369-377 Kentish Town Road

Design Statement

September 2024

This document sets out proposed design updates to the approved scheme at 369-377 Kentish Town Road. The original consent was for a seven story (G+6) building with 14 residential apartments, and Class E (retail) use at ground and basement floor. Planning permission was granted for the scheme in 2020 - application ref: 2019/0910/P.

Fifth Floor Plan

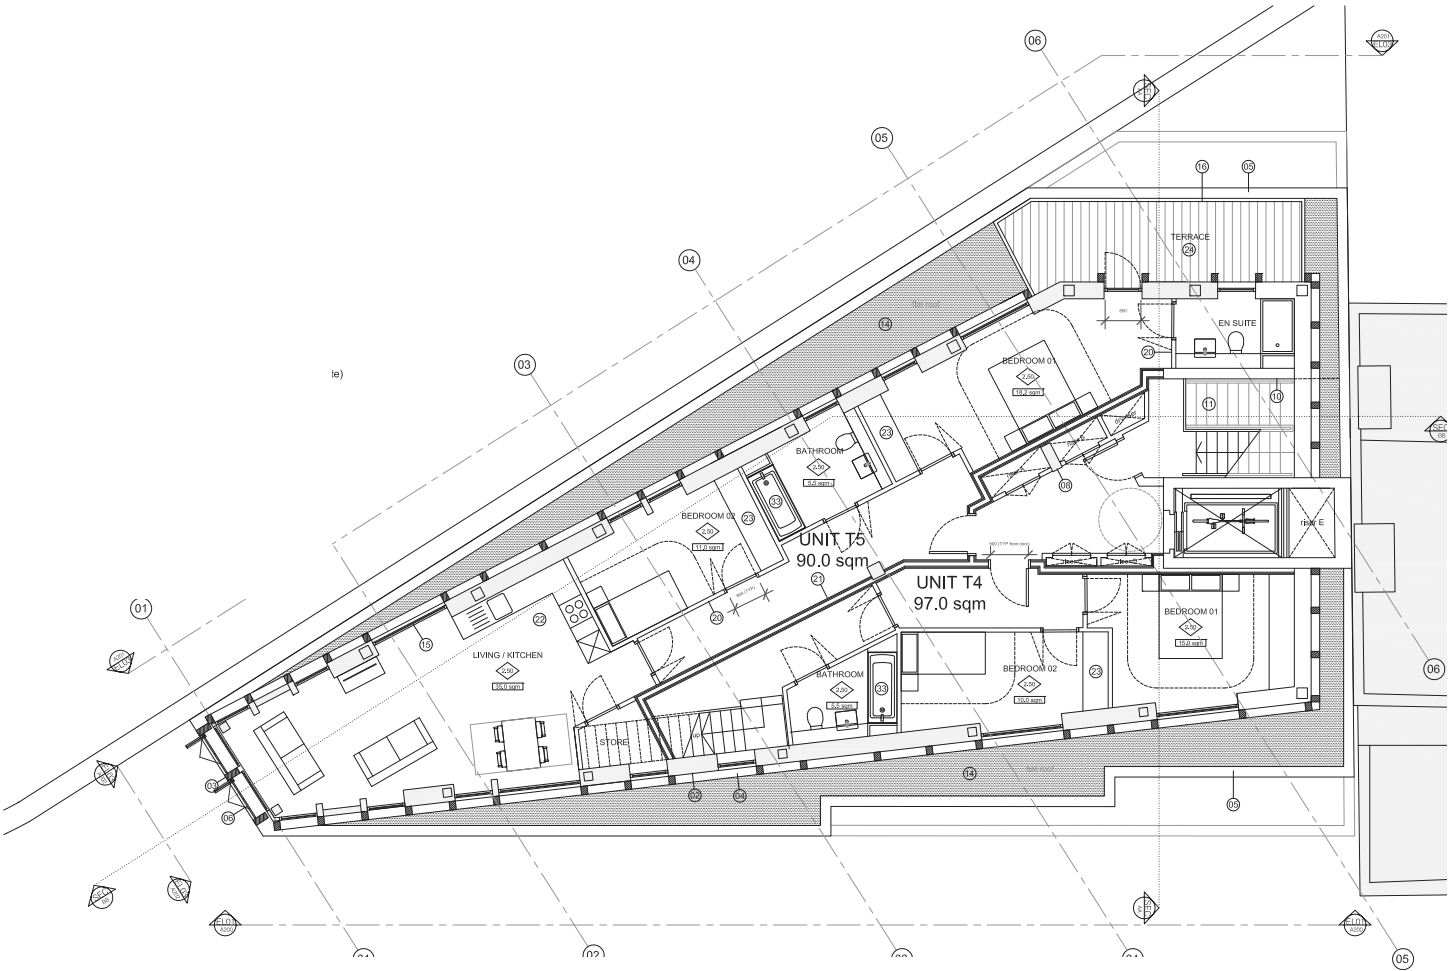
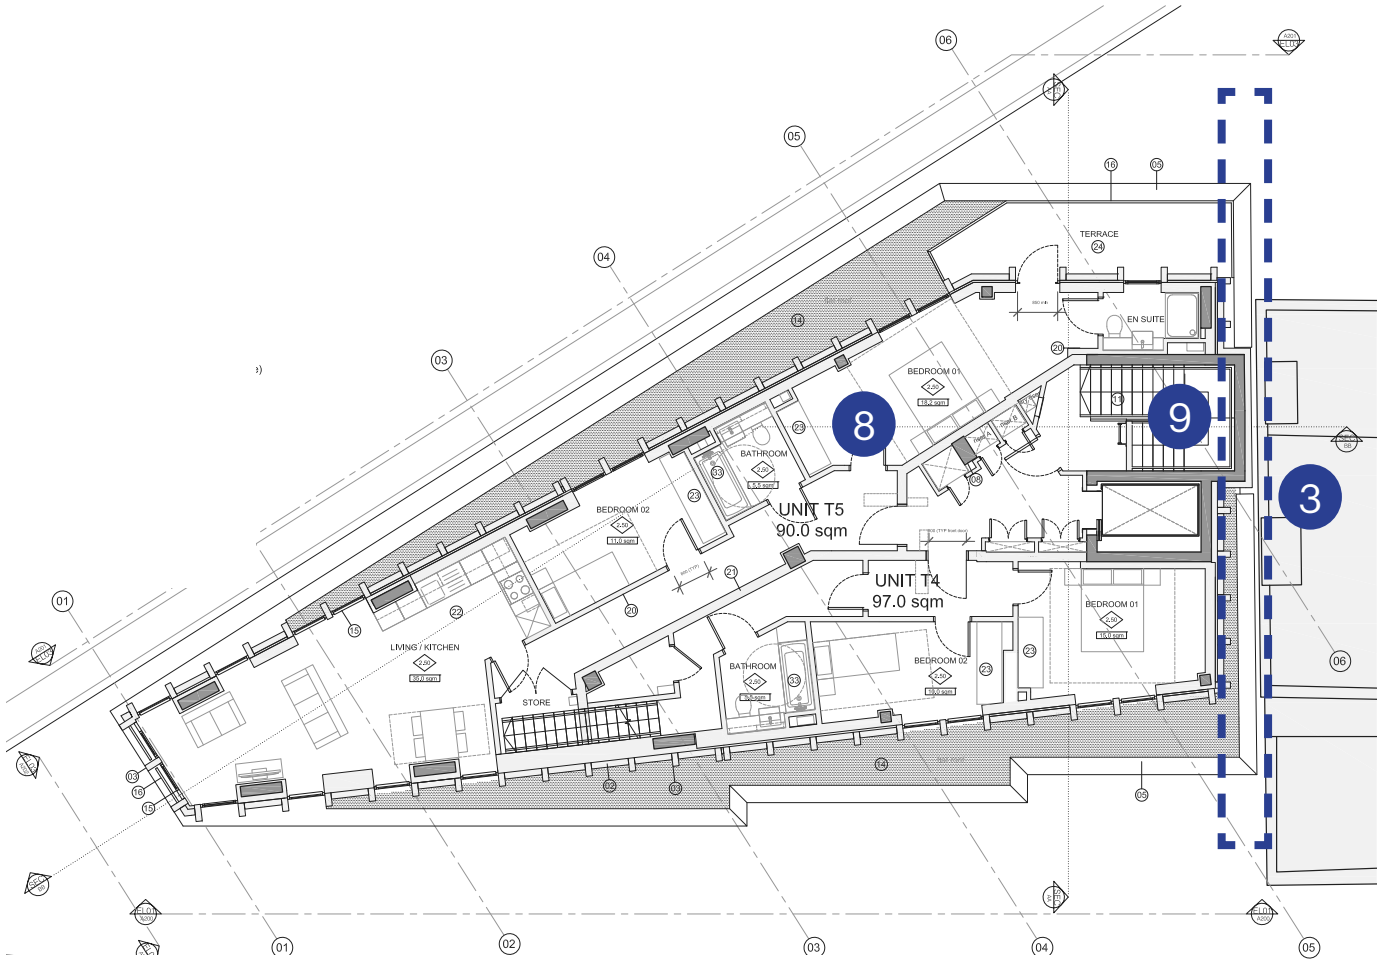
- Plan Updates:
- 3. Party wall moved 150mm away from site boundary due to site tolerances with existing building adjacent.
 - 8. Minor amendments to improve internal layout.
 - 9. Core layout adjusted for improved internal layout.

Sixth Floor Plan

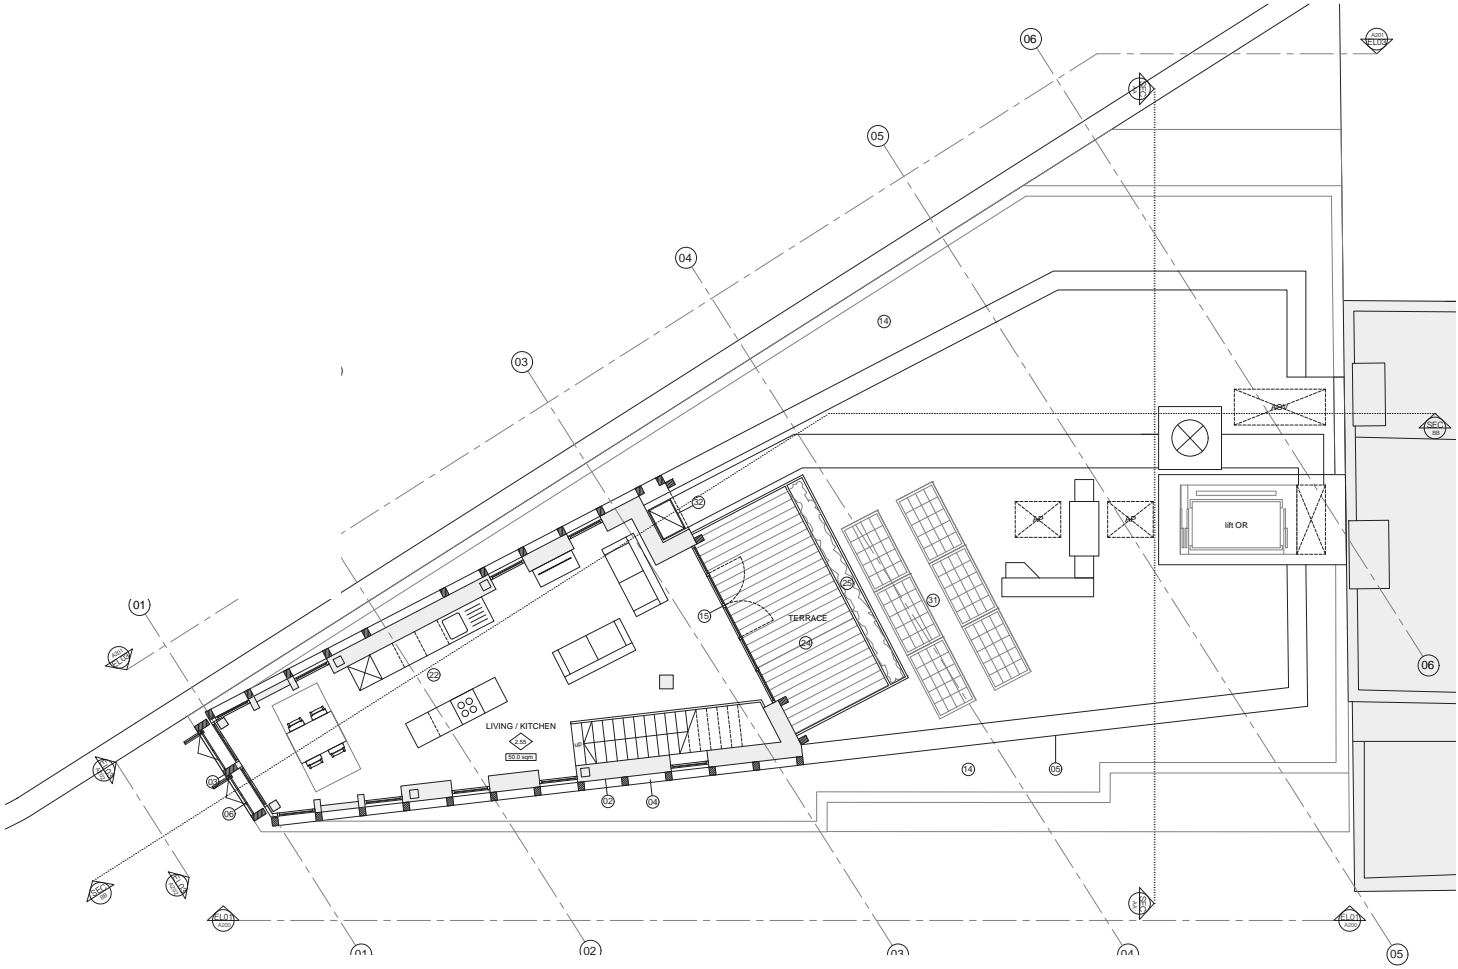
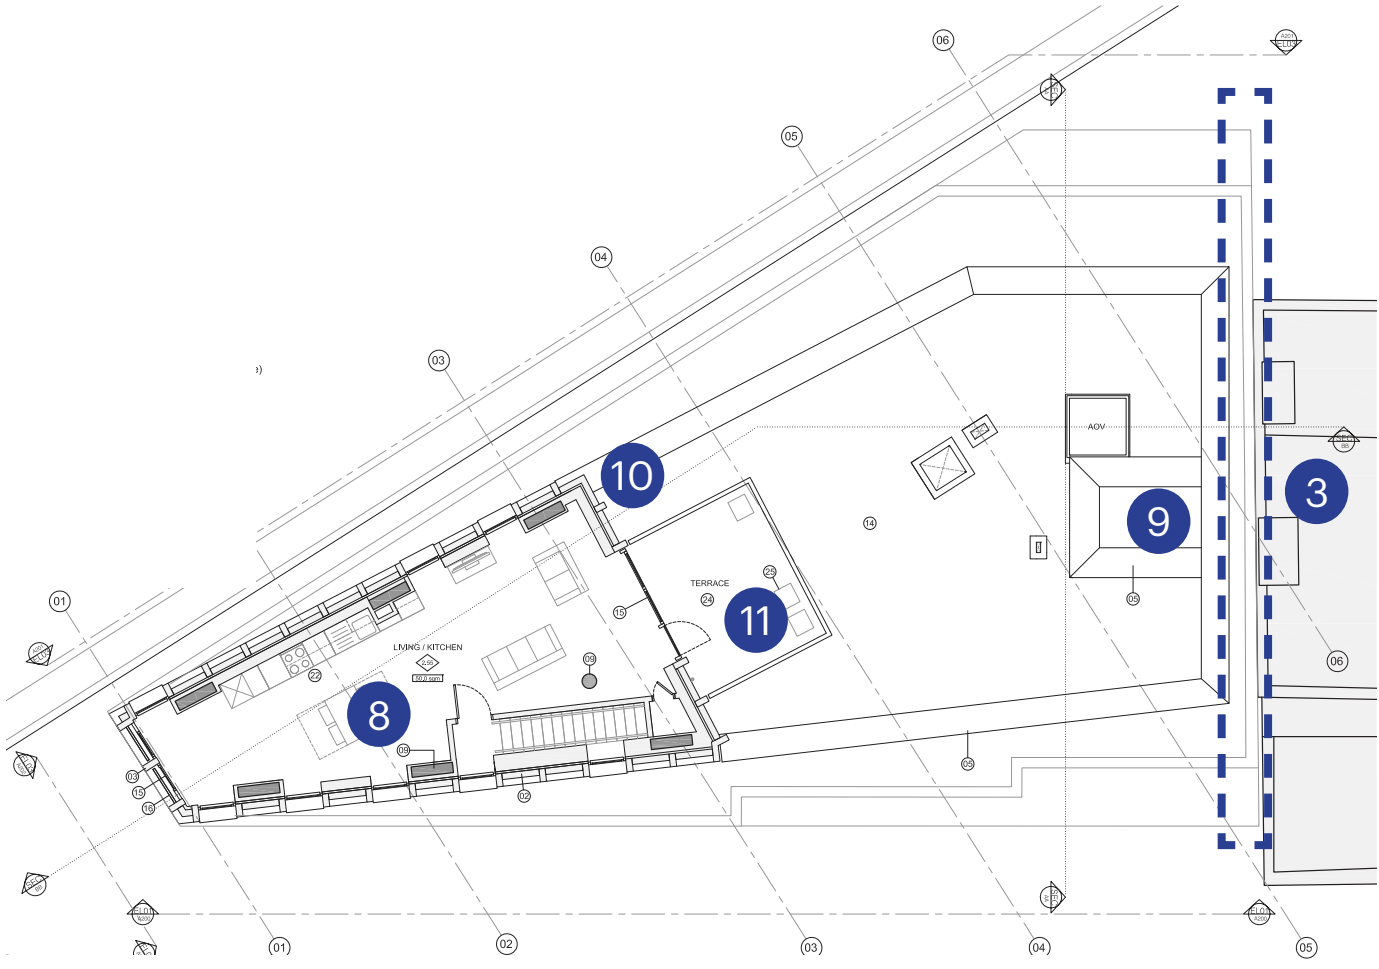
- Plan Updates:
- 3. Party wall moved 150mm away from site boundary due to site tolerances with existing building adjacent.
 - 8. Minor amendments to improve internal layout.
 - 9. Core layout adjusted for improved internal layout.
 - 10. Corner closed off as the space for the boiler flue is no longer required.
 - 11. 6th floor terrace reconfigured.

Roof Plan

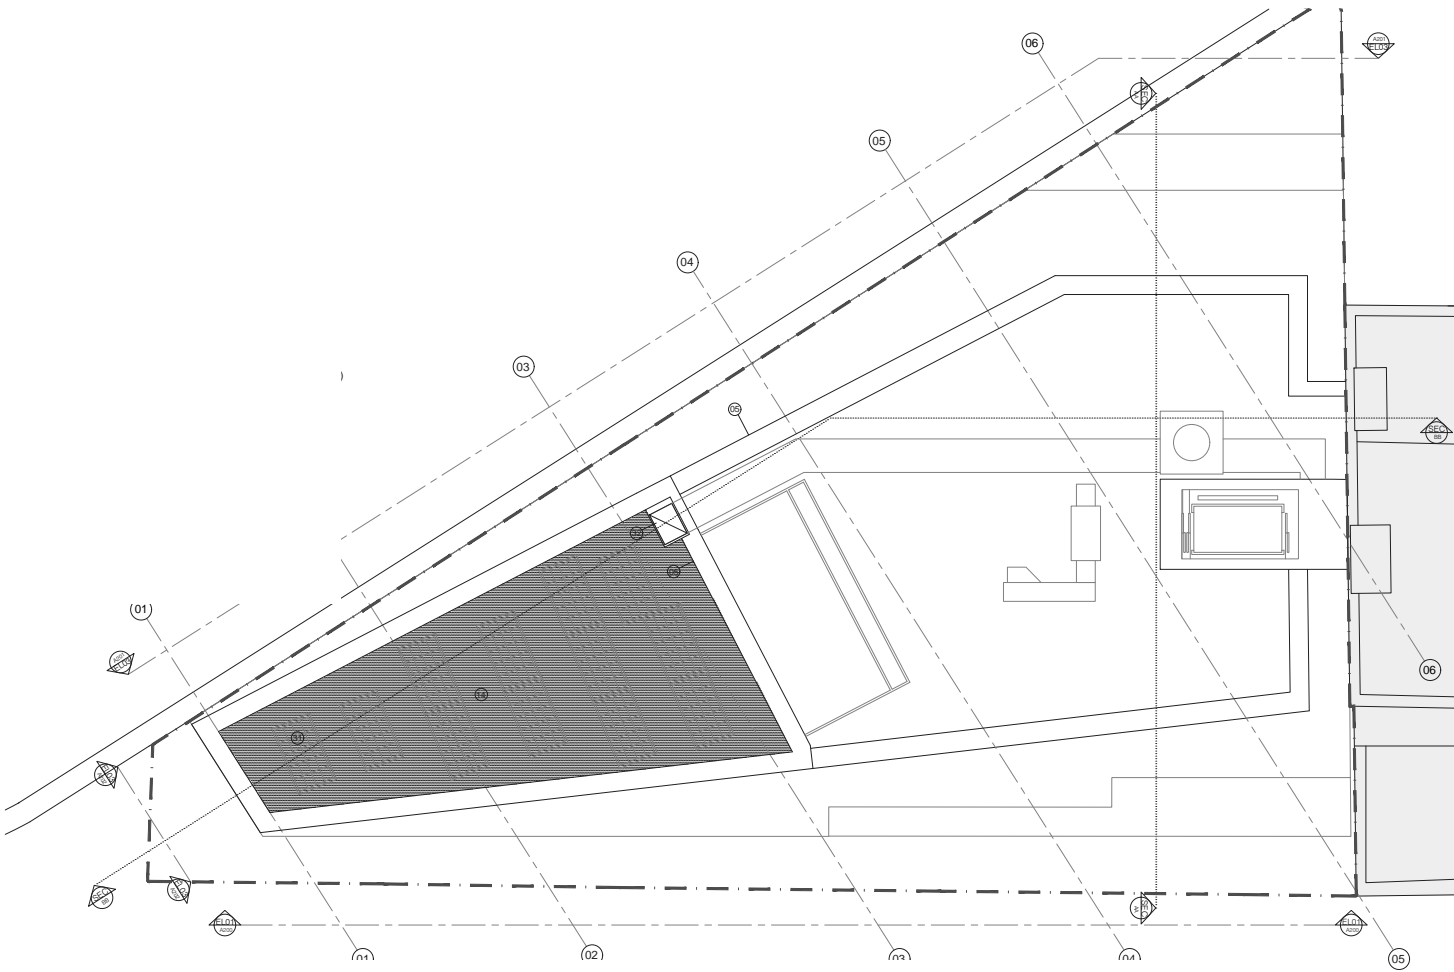
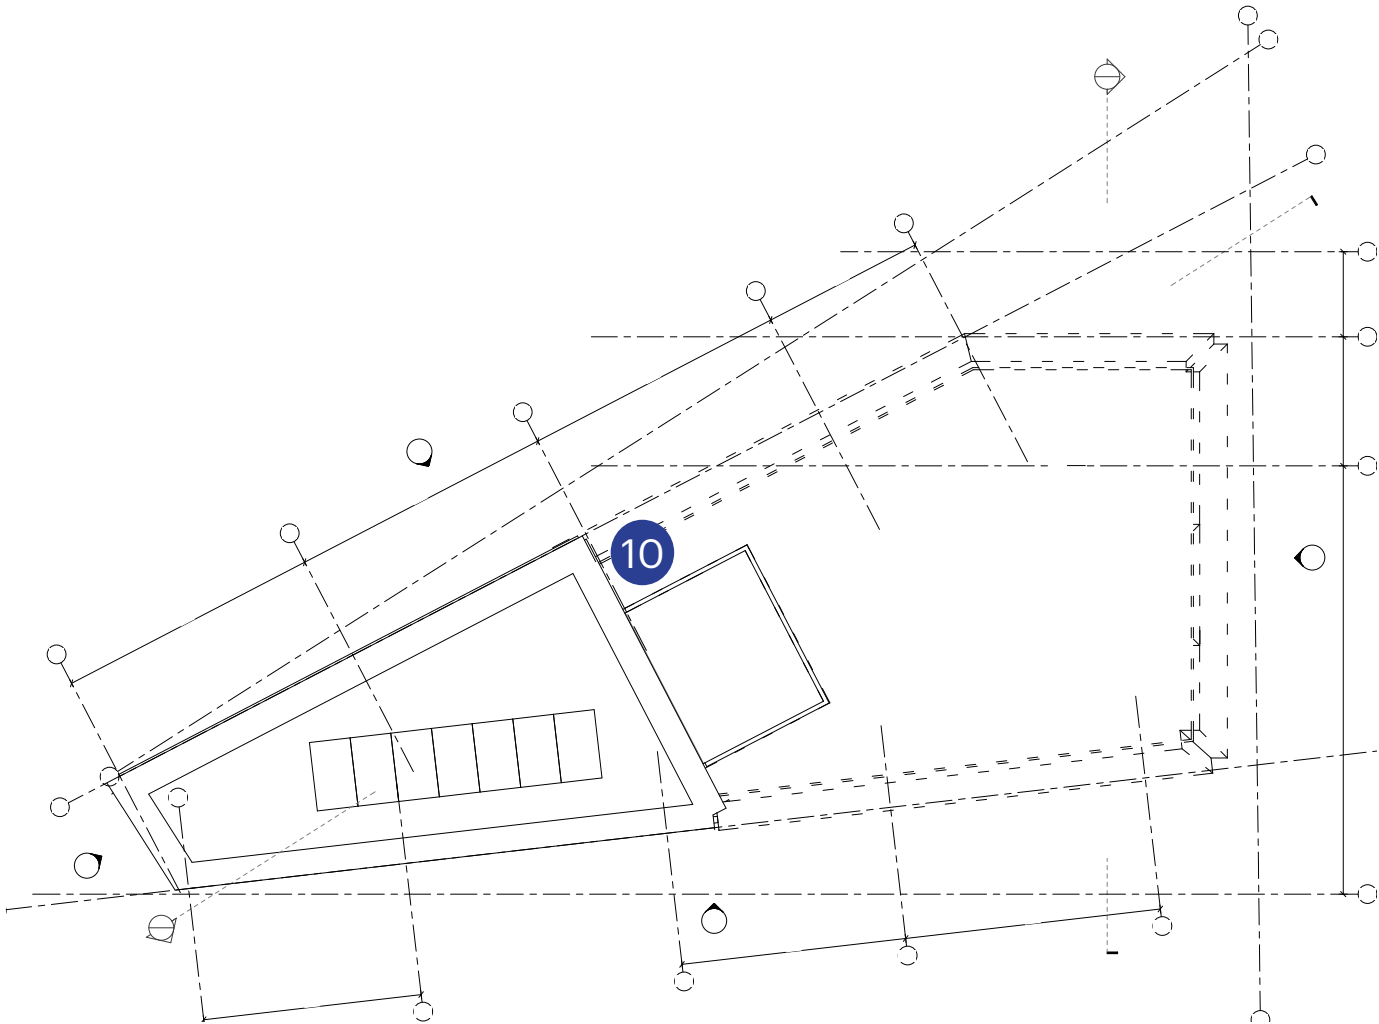
10. Corner closed off as the space for the boiler flue is no longer required.

Approved Scheme - Horizontal Banding Detail

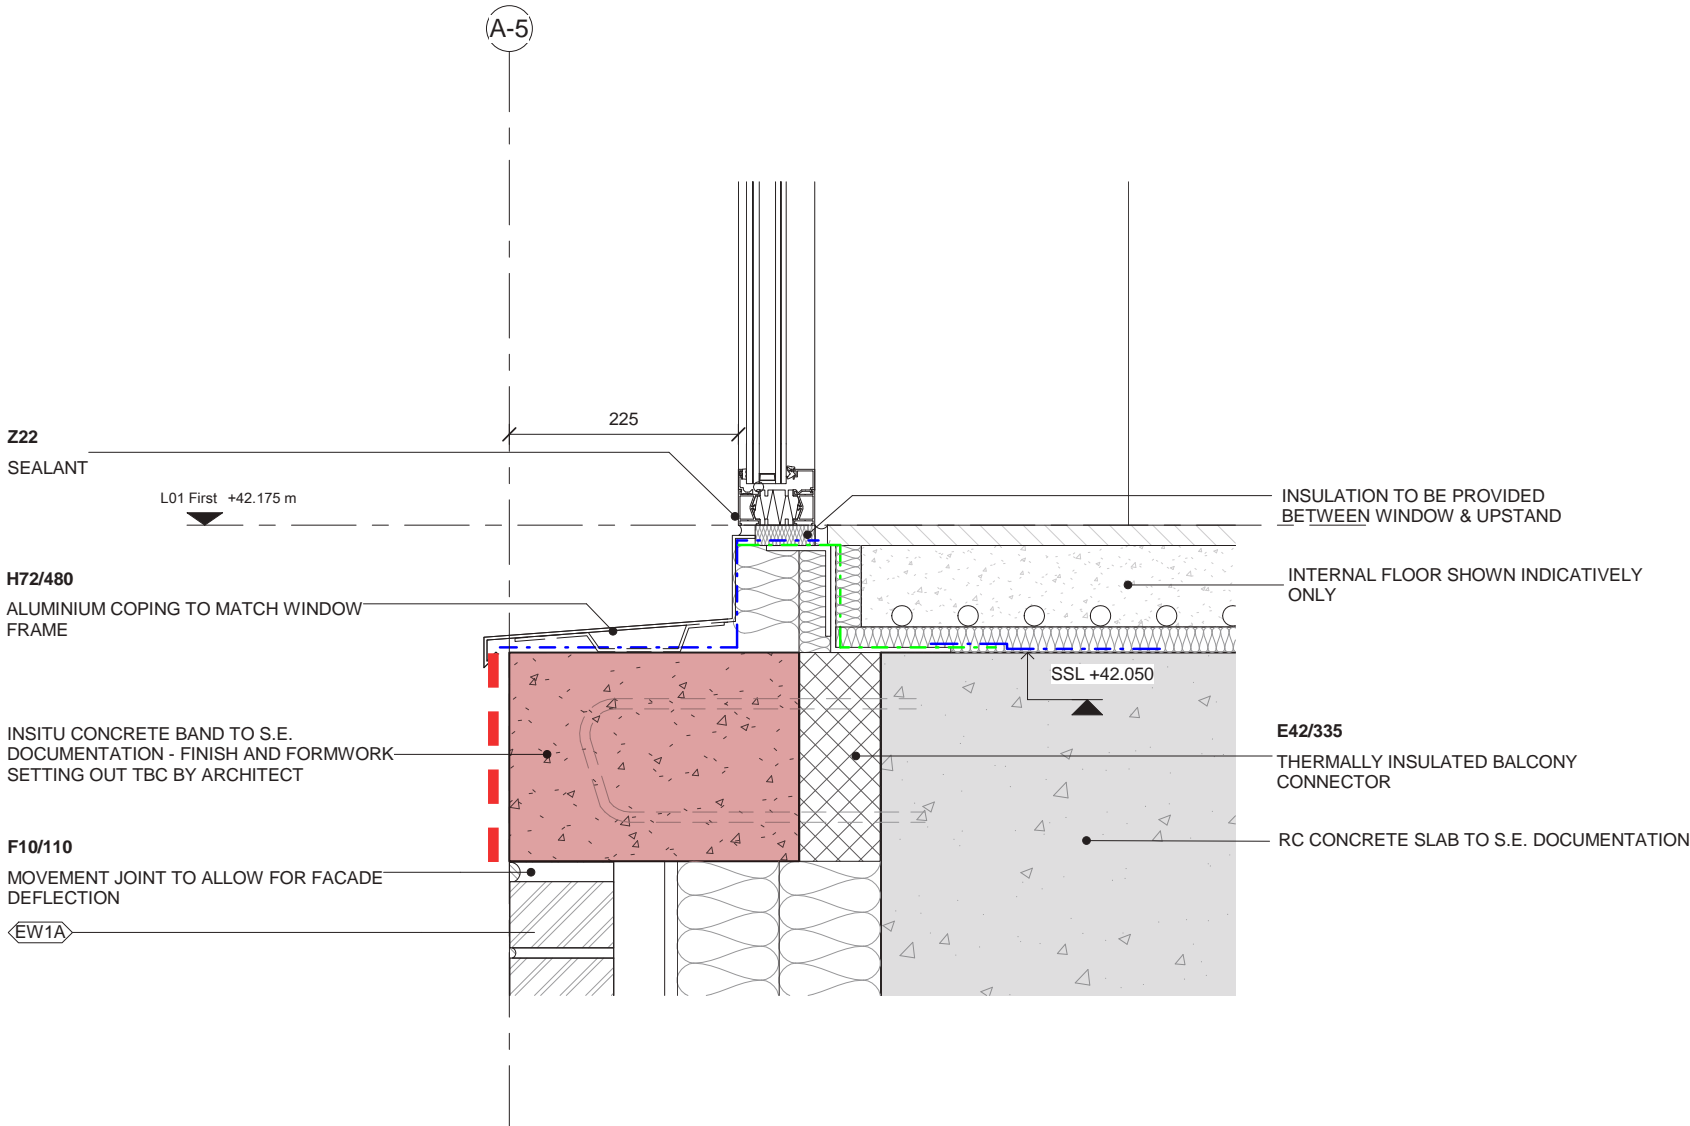
During stage 3 and 4 the detail for the masonry horizontal banding was further developed. As structural elements supporting the stepping brickwork above, the bands have an aesthetic and practical use. On further development of these proposals the following factors were identified:

- Positives:
- 1. Structural concrete bands were required to provide simple solution to support the brickwork on each floor. As the facade is stepping in and out it was agreed that this solution would be most appropriate.
 - 2. Fewer joints would be required compared to a precast option
 - 3. Thermal break and fire stopping is achieved using connectors between the slab and the concrete bands

- Negatives:
- 1. Insitu poured concrete bands would be constructed on site, meaning variation in colour and quality between different pours, and a high chance of poor finish occurring.
 - 2. Issues of tolerance would mean the front face of the concrete bands may not align flush with the face of the brickwork as intended. This could look messy and we would need to consider stepping out the concrete bands by 20mm to deal with this visually. This would create a different look to the facade and mean more aluminium flashing would be required.
